SUBJECT: **Addendum to the Application for Section 404 Individual Permit and Section 401 Water Quality Certification** for the proposed I-26 Interchange improvements at NC 191 (Brevard Road), Buncombe County, Division 13; Federal Aid Project No. IMF-26-1(191)47; TIP Project No. I-5504.

RE: Permit Application for Section 404 Individual Permit and Section 401 Water Quality Certification Submitted on November 21, 2016

Revised permit impact drawings are attached (a full set is provided – changes occurred to permit drawing sheets 2, 3, 4, 7, 8, and 26 of 26). Also attached are the following: DMS Mitigation Acceptance Letter, Biltmore comment response memo, Section 106 (SHPO) email, and Section 7 Concurrence Request Letter.

PERMIT DRAWING
SHEET 7 OF 26

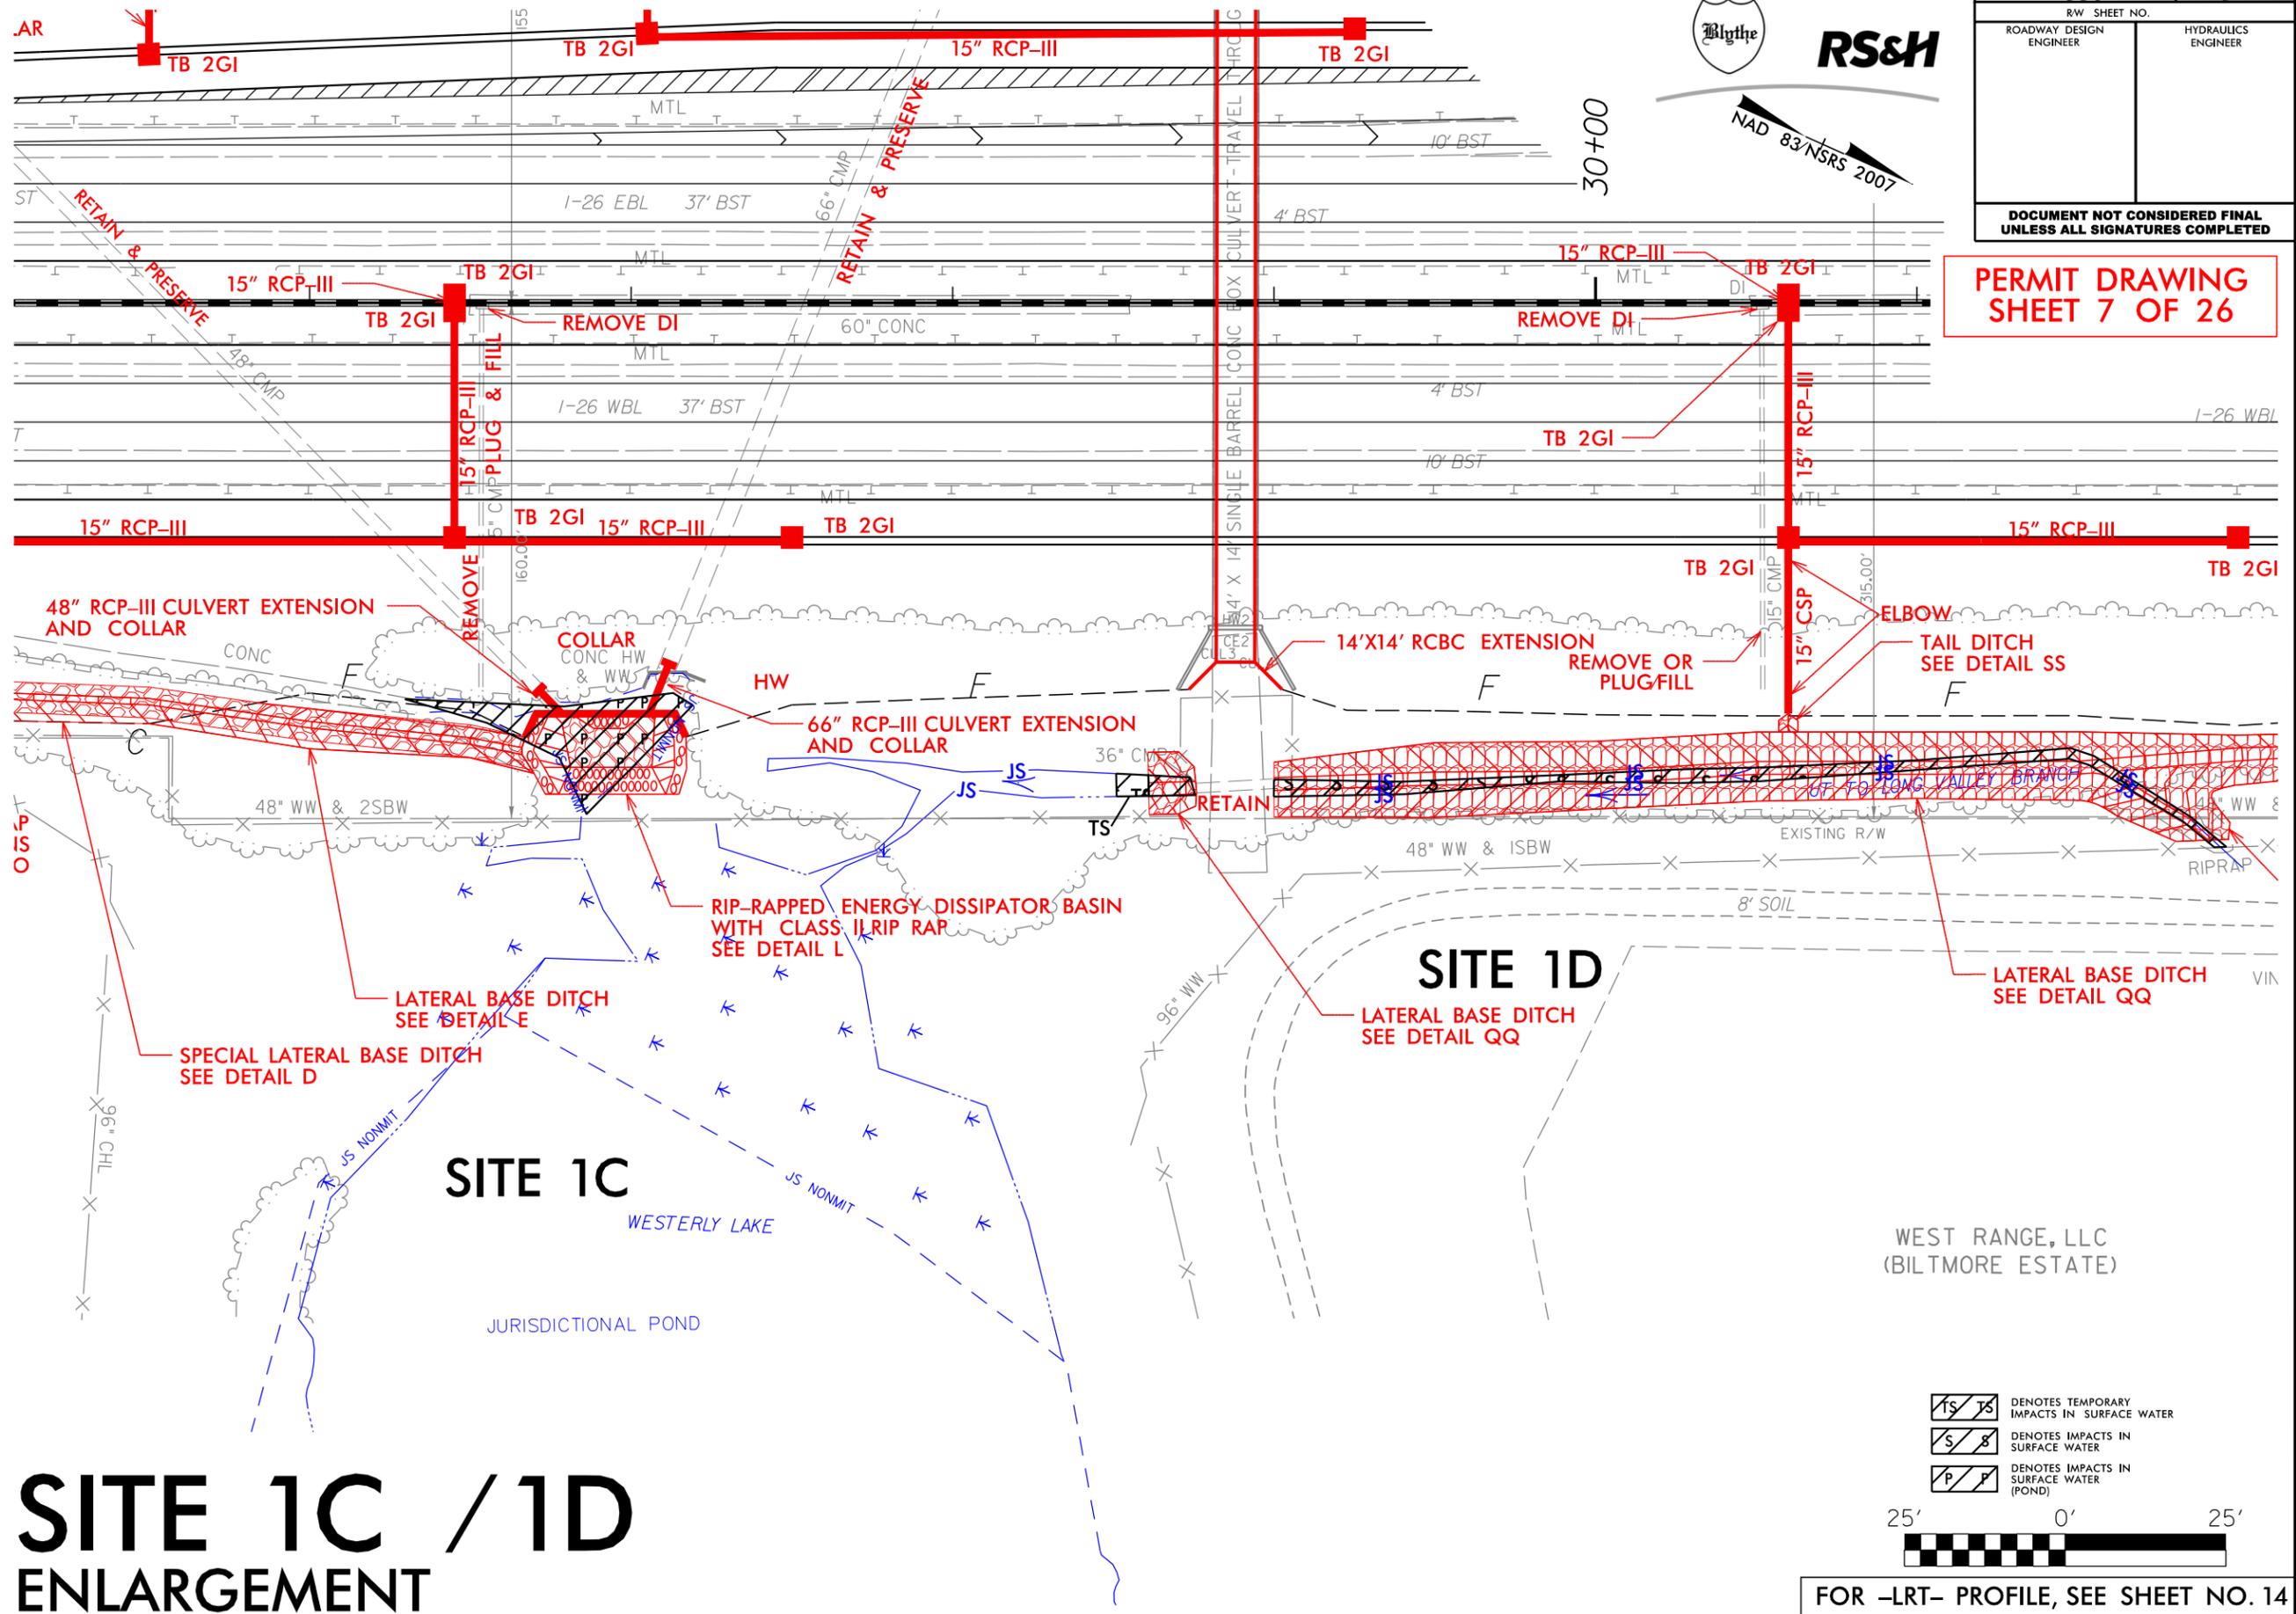
A 15” Corrugated Metal Pipe (CMP) is being plugged and filled, and a new 15” Reinforced Concrete Pipe (RCP) / Corrugated Steel Pipe (CSP) is being installed at this site to assist in proper roadway stormwater drainage. The new pipe will outlet adjacent to a UT to Long Valley Branch/Westerly Lake (Stream SI).

Stream SI paralleling the Biltmore Estate fence will be lined with rip rap for 313 linear feet to address erosion and sediment concerns expressed by West Range through the Section 404 public comment process. In addition, a rip rap ditch has been extended above Stream SI, paralleling the proposed toe of slope of I-26, to further minimize sedimentation from overland flow in this area and to contain the stormwater runoff, keeping it on NCDOT property.

- Proposed 282 feet of additional permanent stream impact for a total of 313 feet. Note the 31 feet shown in the original permit application was for stream bank stabilization only. The 313 feet now proposed would be to completely armor the stream.
 - Proposed 10' of temporary impacts for erosion control devices and dewatering during construction.
2. NCDOT does not propose to change the plans with respect to Westerly Pond. We agree that our design will increase discharges to the pond but our analysis to date does not warrant any changes to our design. We believe addressing potential erosion concerns by way of armoring the contributing drainage ways will address the concerns raised by West Range. It should be noted these post-construction measures are in addition to the erosion control measures that will be used during construction to control erosion.

- [Revised] Sites 1c: The UT from the outlet of the 14'x14' RCBC (Stream SI) to Westerly Lake will be avoided except for placement of mats or other devices over the stream (above ordinary high water mark) for construction equipment access;
- [Added] Site 1d: The UT adjacent to I-26 (Stream SI) will be lined with rip rap to limit sediment transport to Westerly Lake.
